DOCUMENT TITLE	Surface Water Drainage - SCC Explanatory Note	CWA REVISION	01
-----------------------	---	---------------------	----

Project:	SZC Enabling Works Detail Design		
Subject:	Surface Water Drainage - SCC Explanatory Note		
Author:	DH		
Date:	Project No.:	5199744	
Atkins No.:	N/A	Icepac No.:	[Not Used]
Distribution:	[Not Used]	Representing:	[Not Used]

This document has been prepared to provide further background related to the surface water management proposals for Sizewell C (SZC) nuclear power station Enabling Works Basic Design (EWBD). This note provides responses to the technical queries raised by Suffolk County Council (SCC) and aims to provide information where available for the following sections. The items numbered below correspond to the Surface Water Drainage Action Plan:

Figure 4-1 – Indicative Swale Network Overview (ref. SZC-EW0320-ATK-XX-000-XXXXXX-DRW-CCD-000038)

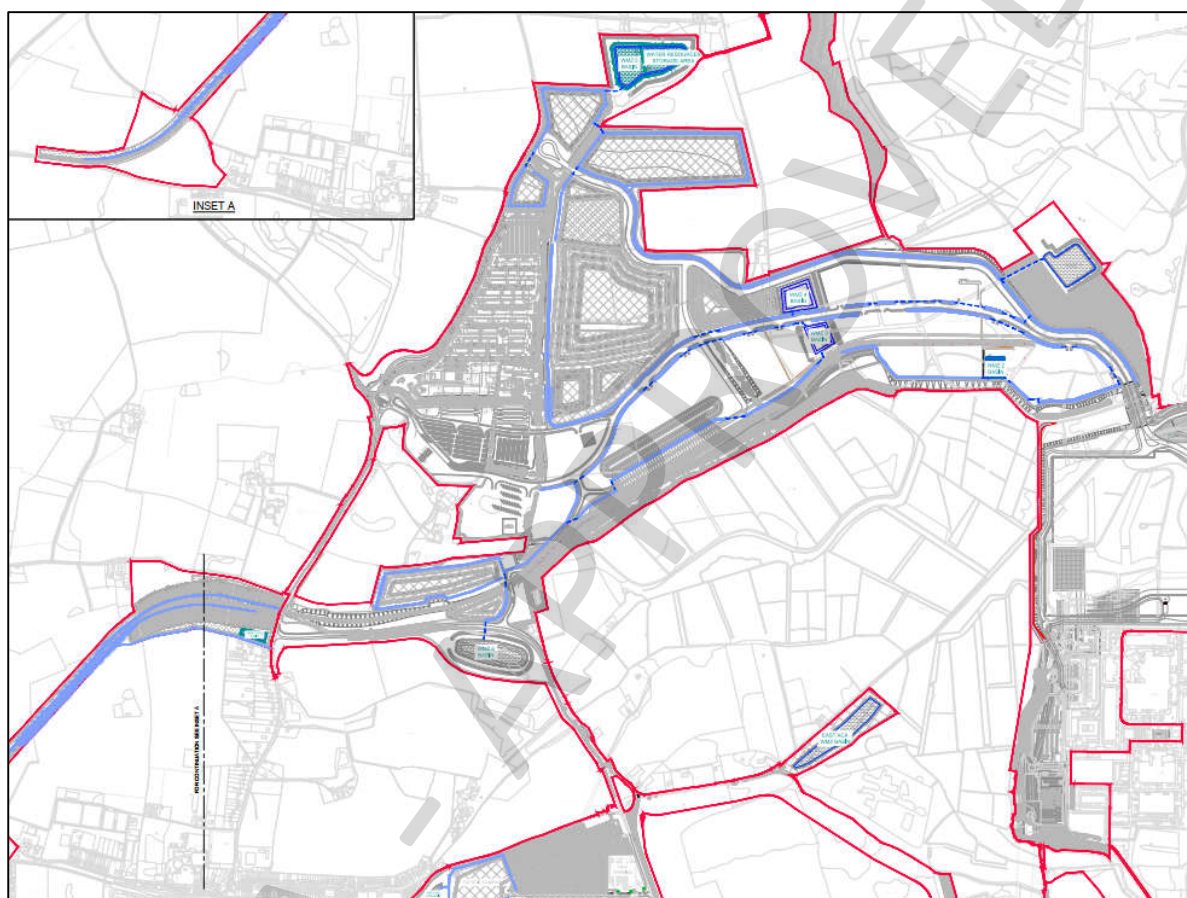
4. Perimeter Swale

An overview of the swale network is provided indicatively in Figure 4-1 below and in Appendix C. The swales shown on the drawing are between 4 and 6 m wide across the site. The final position and geometry of the swale network will be progressed during the next design stage and will ensure water quantity and quality benefits are realised in accordance with CIRIA C753 The SuDS Manual. This may entail dedicating a larger area for this purpose, and the provision of additional swale features across the development site.

Figure 7-1 - Existing Ground Contours (SZC-EW0000-XX-000-DRW-400008)

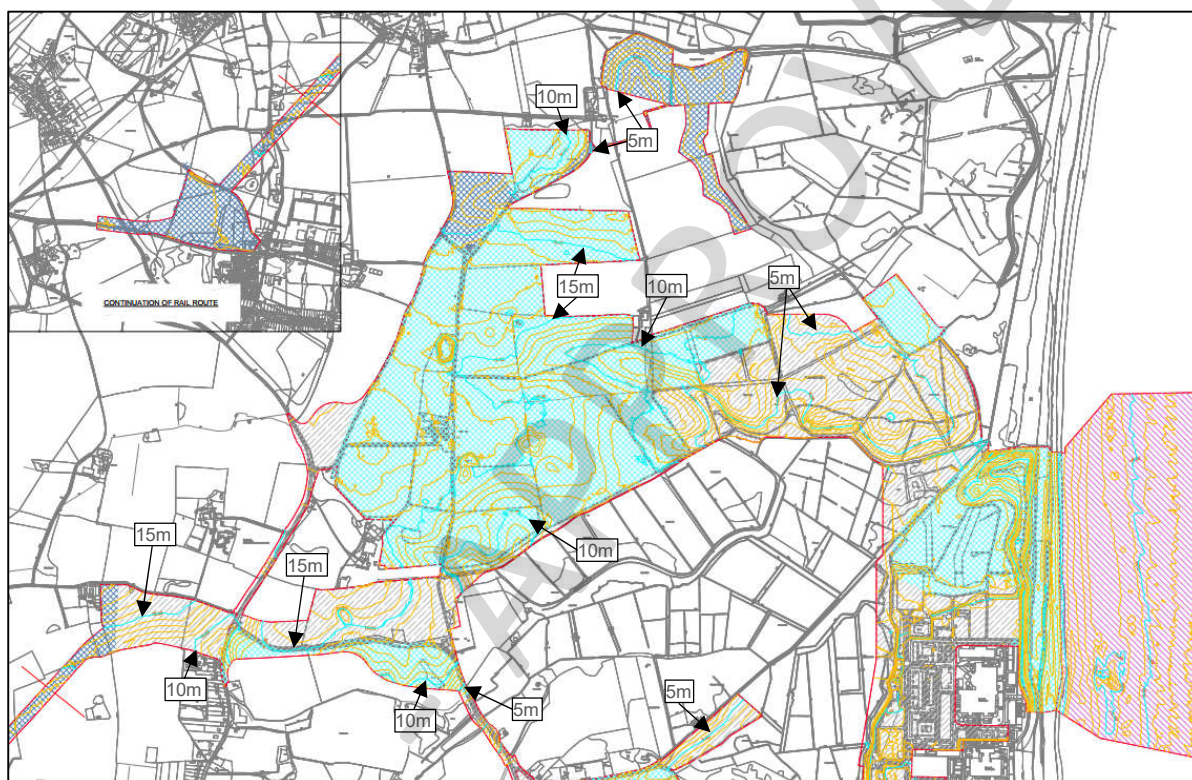
7. Hydrological Catchment

The existing ground (surface) contours can be seen in the drawing 'Existing Ground Surface ref. SZC-EW0000-XX-000-DRW-400008' (Appendix B). The contours defined are at 1m (minor - yellow line) and 5m (major – cyan line) intervals. Early catchment areas were defined based on the existing levels and contour information. These catchments are approximations of where surface water would generally flow with some consideration of where runoff may be diverted/captured as a result of the initial earthworks. In places, land external to the red line boundary was included as part of the early catchment areas, as it is shown to contribute to surface water runoff within the SZC site.
